# Riva Townhomes

Project No. PRJ14-00023, SDP15-00004

Site Development Permit  
Development Commission Public Hearing  
March 9, 2016

# Riva Townhomes, SDP15-00004

# Through Block Passage

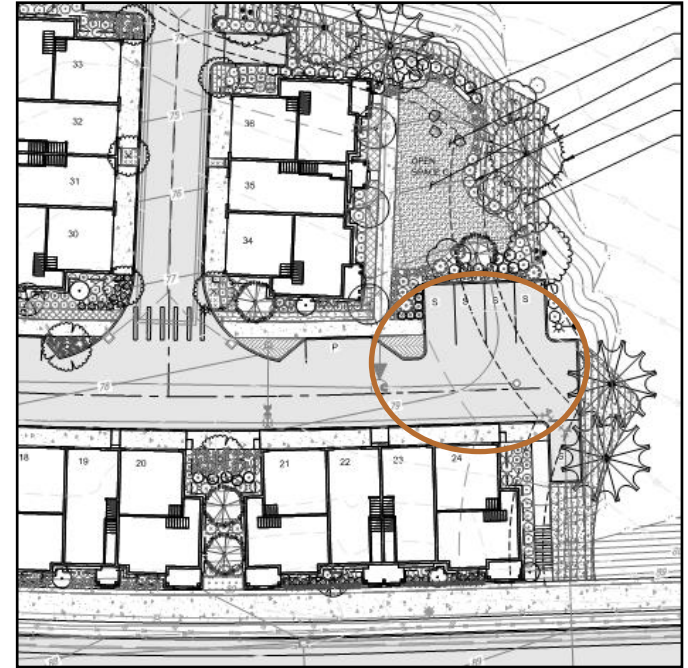
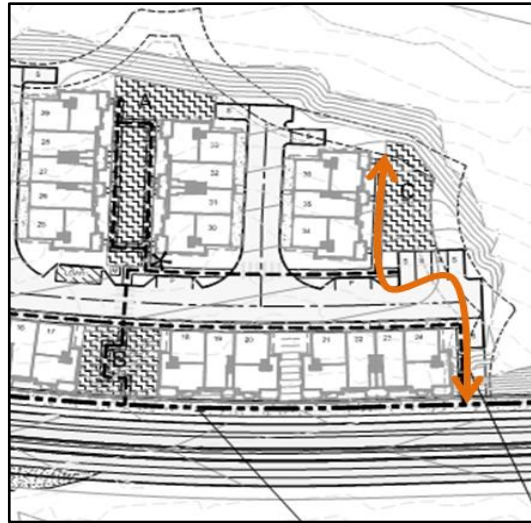
**Recommended Condition 4:** A 10-foot wide sidewalk shall be provided to serve buildings 34 to 36 and the communal open space/nature-based play area.

**Recommended Condition 6:** The Primary Through Block Passage serving buildings 34 to 36 shall be provided with a consistent and continuous sidewalk from Newport Way to building 36. Where the pedestrian path is interrupted by the surface parking spaces and the alley, the alley and parking area shall be designed as a pedestrian plaza (i.e., with special paving) so that it visually connects the community open space with the Primary Through Block Passage and Newport Way. The sidewalk of the Primary Through Block Passage at the section connected to Newport Way shall be 10 feet wide.

**Recommended Condition 16:** Remove single surface parking space next to unit 24 and connect the exterior stairs to Open Space C and Primary Through Block Passage serving units 34 to 36.

# Required Community Spaces

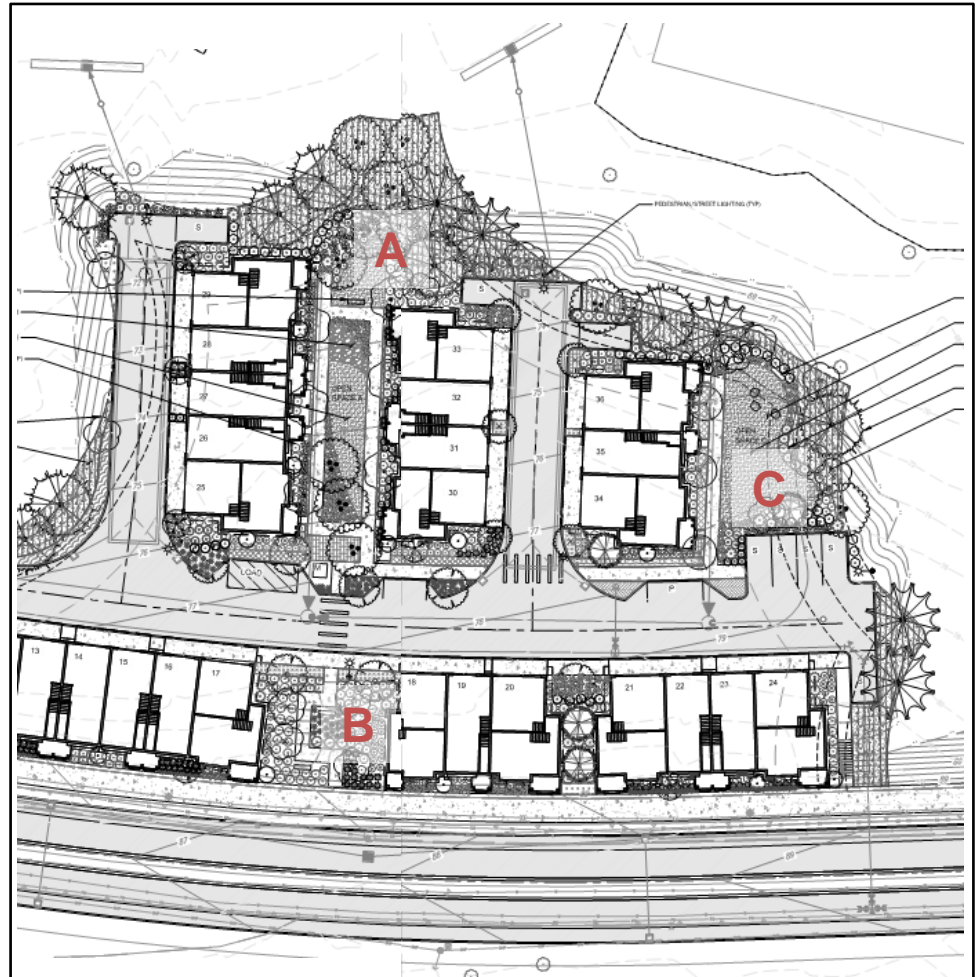
**Condition 7:** An On-Site Amenity, with a minimum size of 400 s.f., shall be provided. The nature-based play area may partially or completely fulfill this requirement.

**Condition 8:** The play equipment and landscape details of the nature-based play area shall meet the requirements in CIDDS 13.4 at a minimum.

# Site Design: Sense of Place

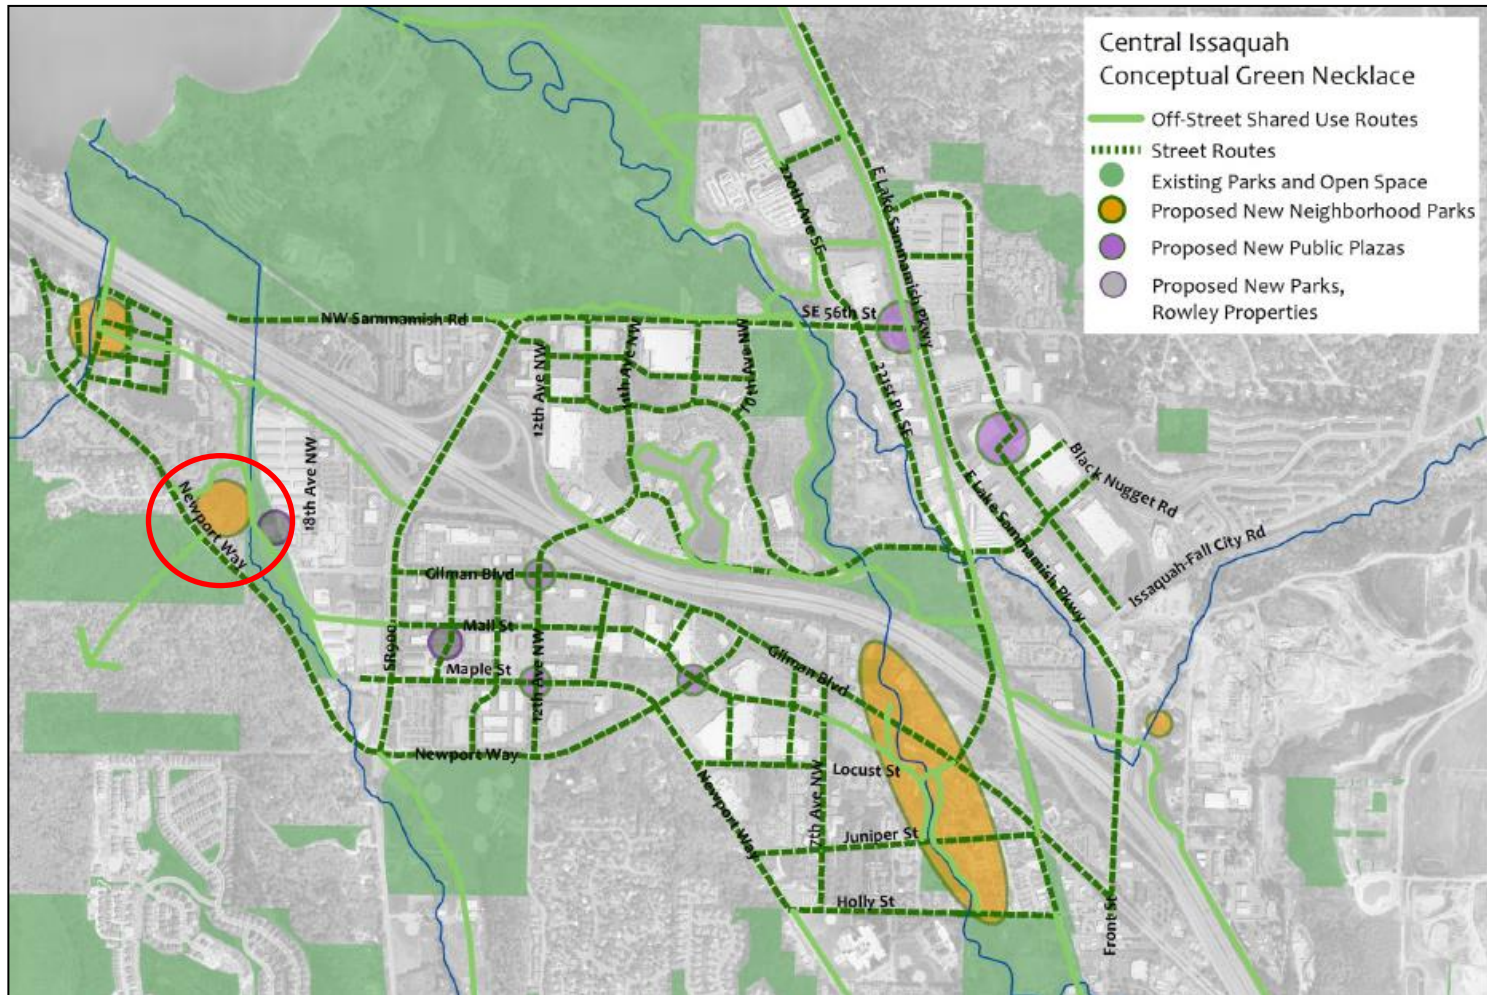
**Recommended Condition 22:** The building elevations shall be further refined to incorporate natural materials.

## Primary Through Block Passage

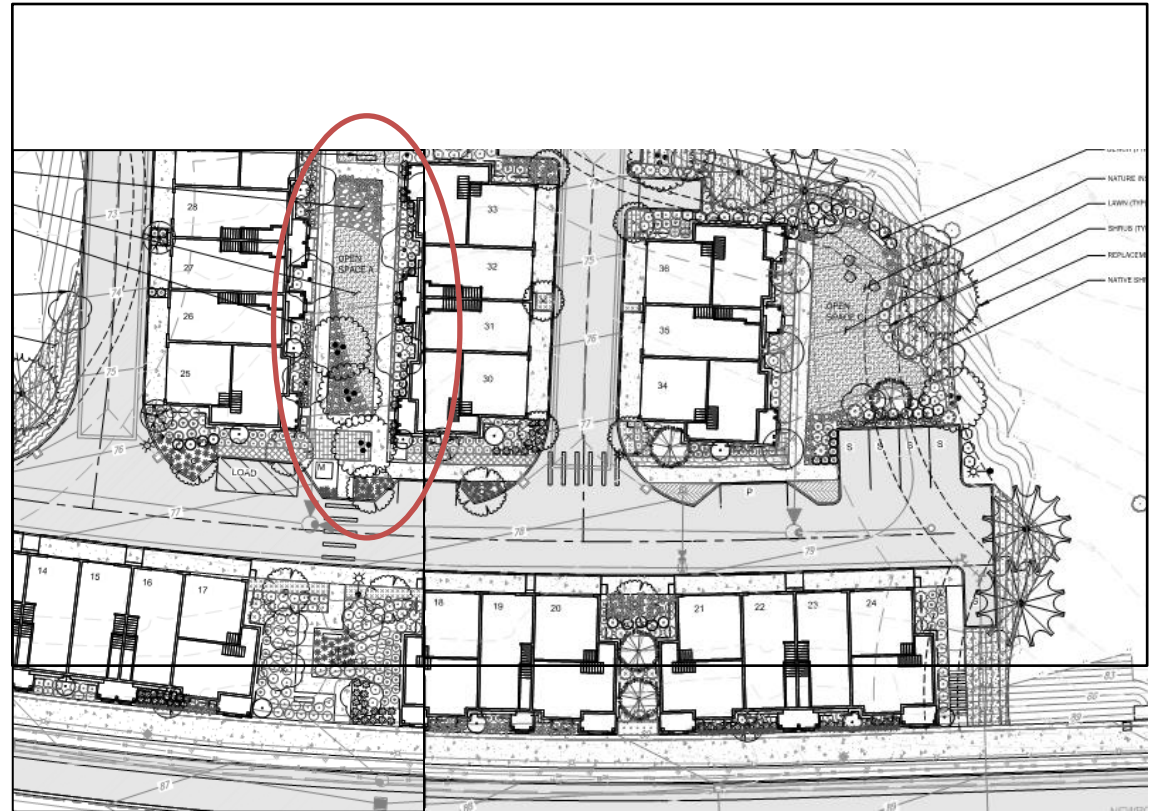
CIDDS: 10-foot walkway  
at center

Proposed Adjustment: Two 5-foot  
walkways, split into sides

**67' R/W : PARKWAY SECTION WITH 12' TURN LANE**

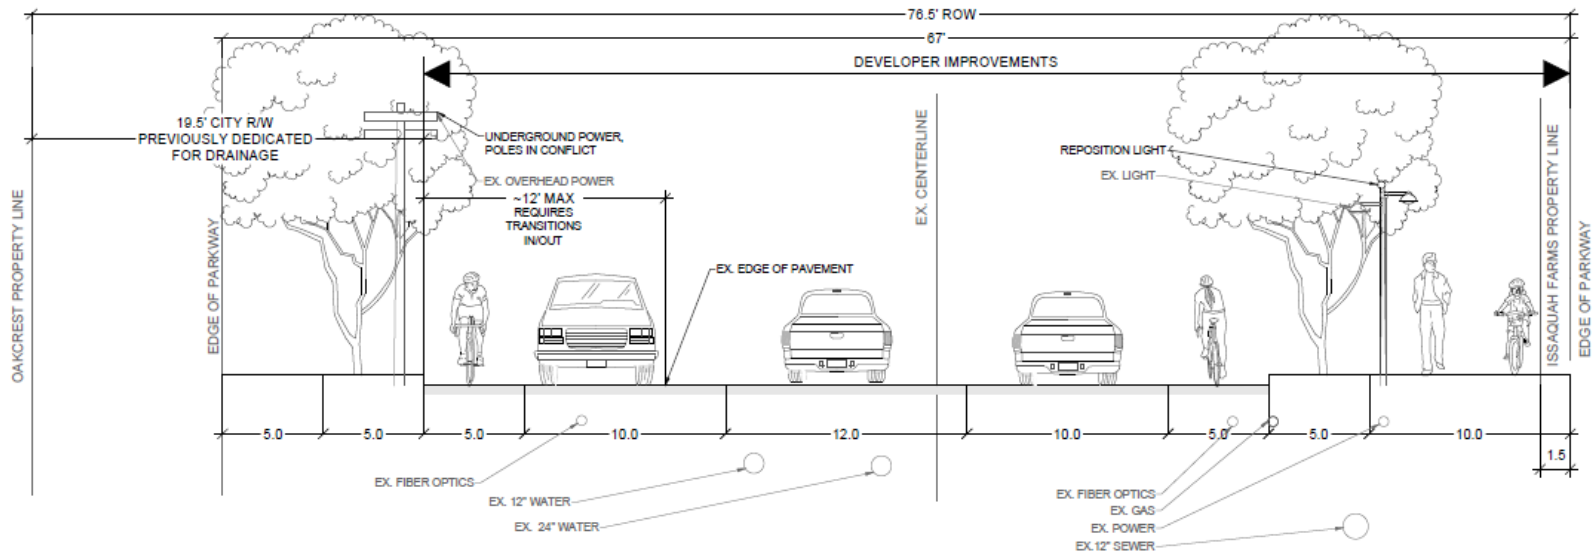
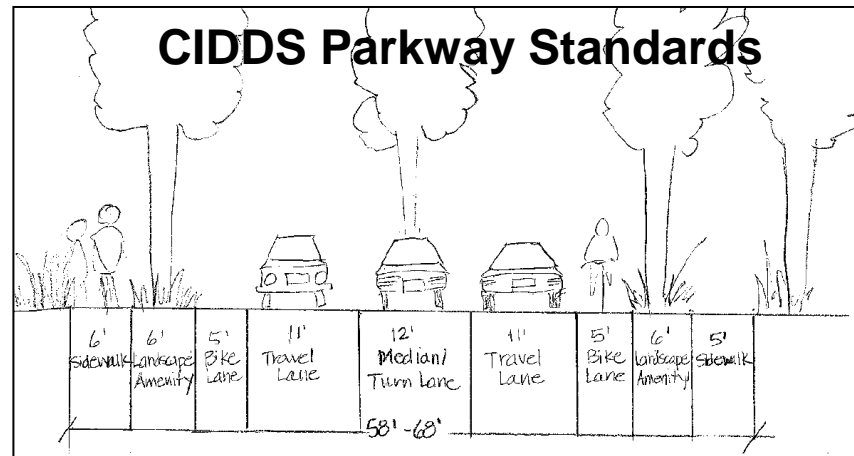
Proposed Adjustment:  
reduce travel lane of  
Newport Way from 11  
feet to 10 feet
